**CITY OF AUSTIN
Board of Adjustment
Decision Sheet**

CASE NUMBER: C15-2020-0020

ADDRESS: 1401 3RD ST

VARIANCE REQUESTED: The applicant is requesting a variance(s) from Section 25-2-492 (Site Development Regulations) from setback requirements to decrease the minimum interior side setback from 5 feet (required) to 2.77 feet (requested) in order to complete a Single-Family residence in an "SF-3-NP", Single-Family Residence-Neighborhood Plan zoning district. (East Cesar Chavez Neighborhood Plan)

Waterloo Surveyors Inc.
SURVEY PLAT

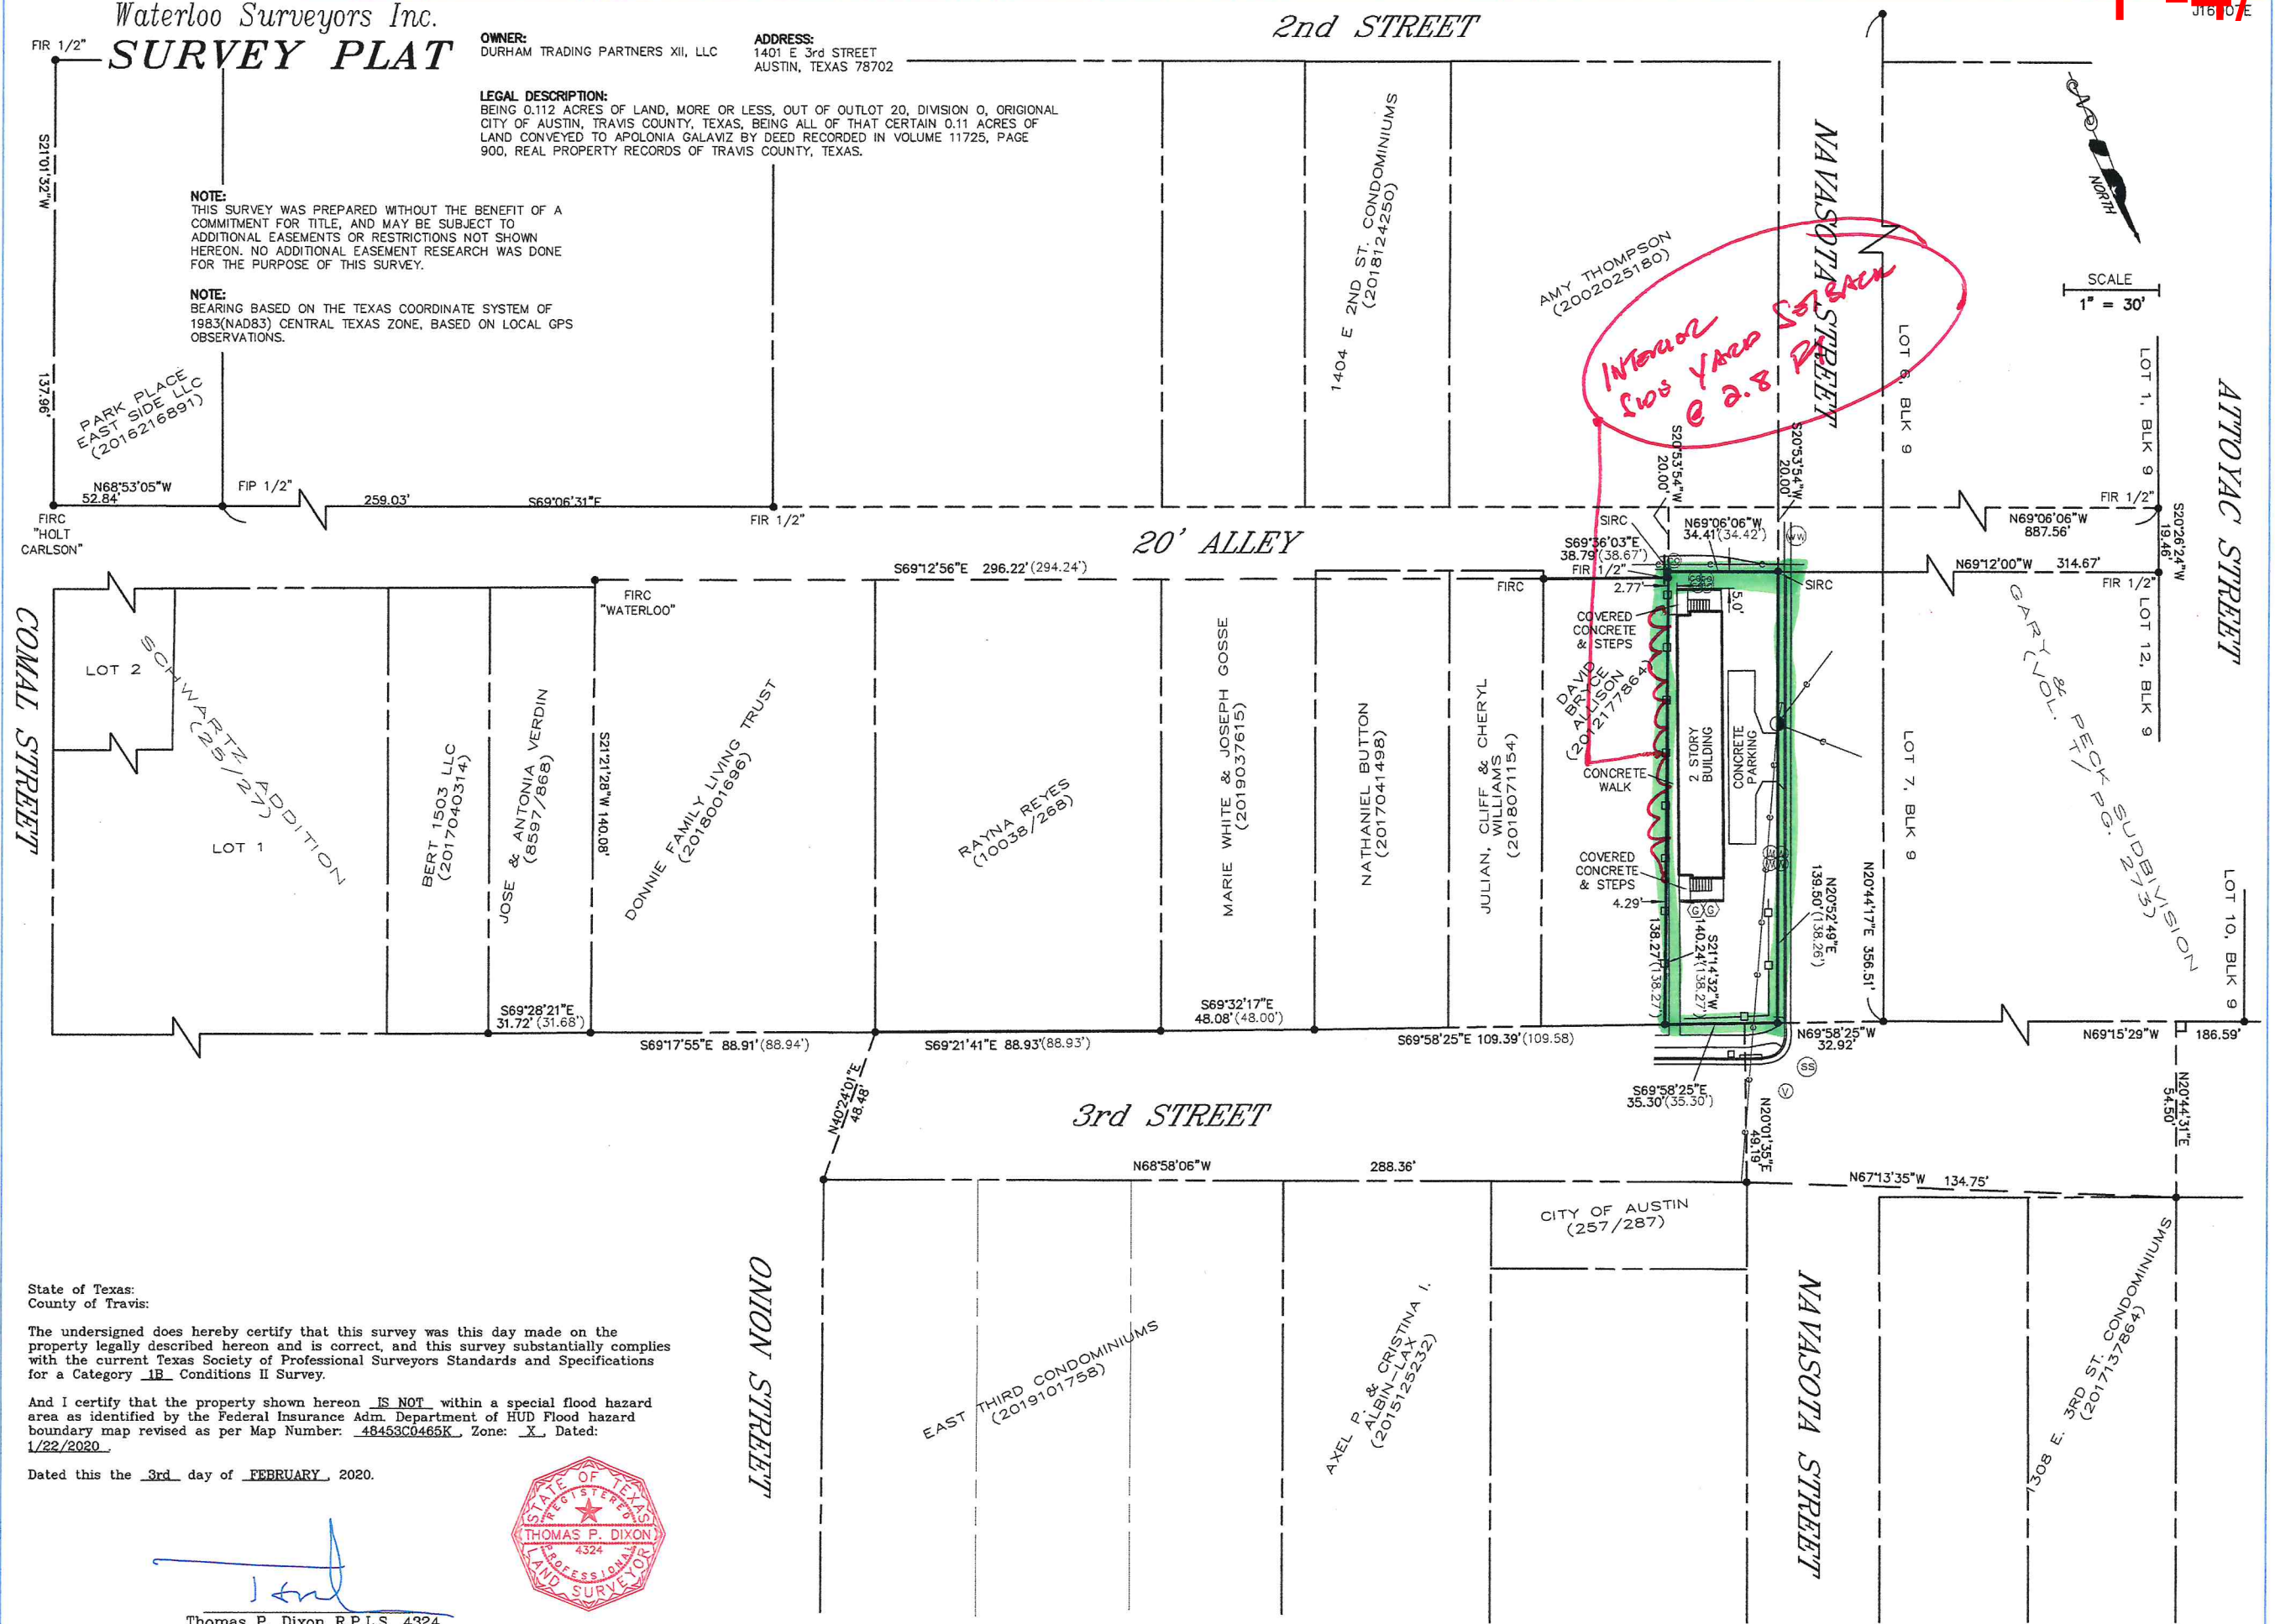
- A survey error based on confusing ROW widths in the adjacent alley created a 2.7' side yard setback during construction of the SFR & accessory apartment.

- The new single-family residence has a varying encroachment into the 5' side yard setback, creating a side yard setback ranging from 2.77' to 4.0'.
- There are no known examples like this in the immediate area, but is probable in the larger east Austin geography.

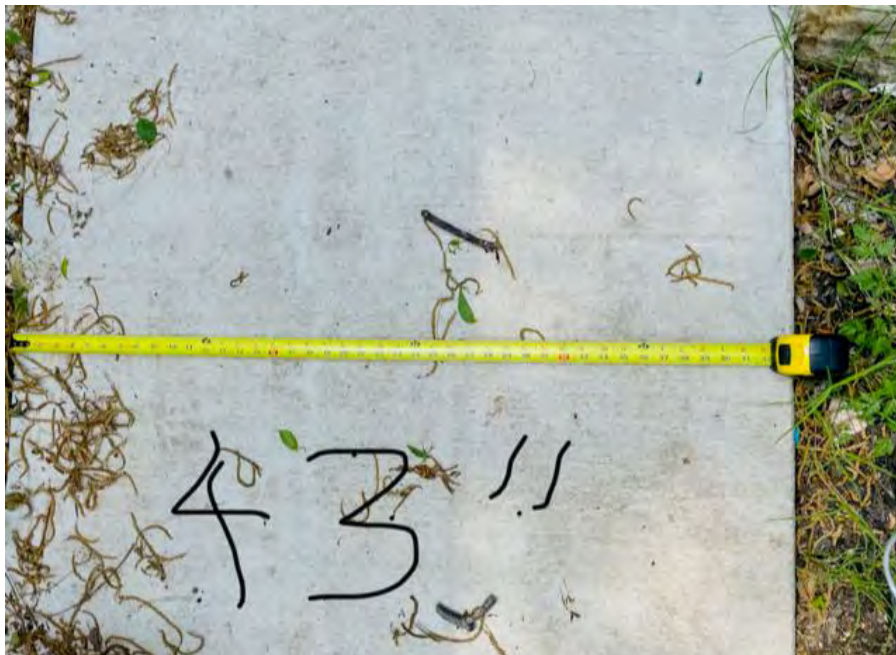
- **82 inches.** At the northeast corner of the structure, the as-built clearance between 1401 E 3rd Street and the abutting historic structure at 1403 E 3rd Street is 82” (6’-10”). The City’s official side-lot setbacks call for 10’ of clearance; the as-built clearance is 68% of what is required.

- **43 inches.** As currently built, the width of the first-floor entrance sidewalk is 43”. Since the fence between properties is not on the lot line, this clearance is not guaranteed going forward.

- **18 inches.** The approximate distance that the exiting fence built by Durham Trading Partners encroaches on the abutting property at 1403 E 3rd Street is 18”. Note that the existing sidewalk straddles over the lot line by approximately 10”.

- **33 inches.** If the abutting property owner ever moves the fence to the lot line, the width of the first-floor entrance sidewalk will be reduced to a non-ADA-compliant width of 33”.

EXHIBITS

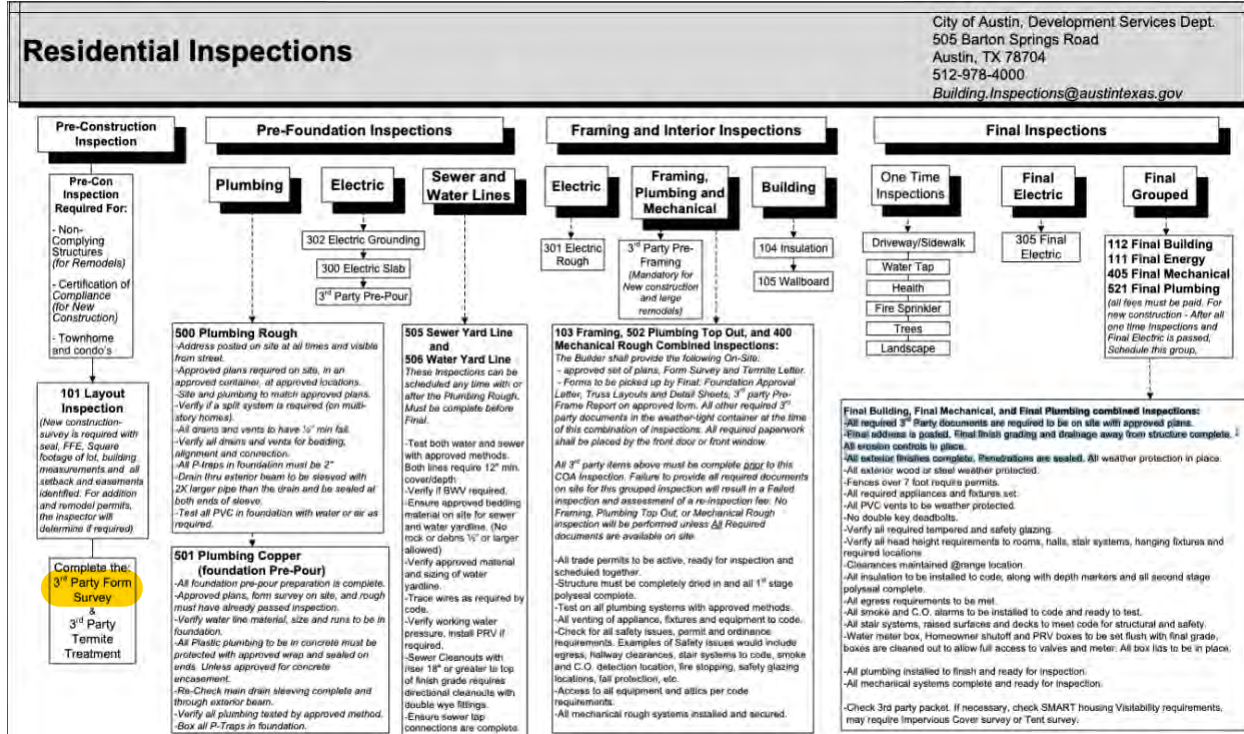
The City of Austin's published Residential Inspection flowchart clearly indicates that a 3rd Party Form Survey is a prerequisite to any pre-foundation construction activities. This process ensures that a licensed surveyor has confirmed and verified the foundation form locations *before* the developer sets anything is set in stone.

If so, the only explanation for a side lot setback error is that Durham Trading Partners failed to retain its 3rd party professional, Waterloo Surveyors, to visit the site to conduct a form survey. While that oversight is unfortunate, it does not merit a variance. The BOA should not reward bad actors.
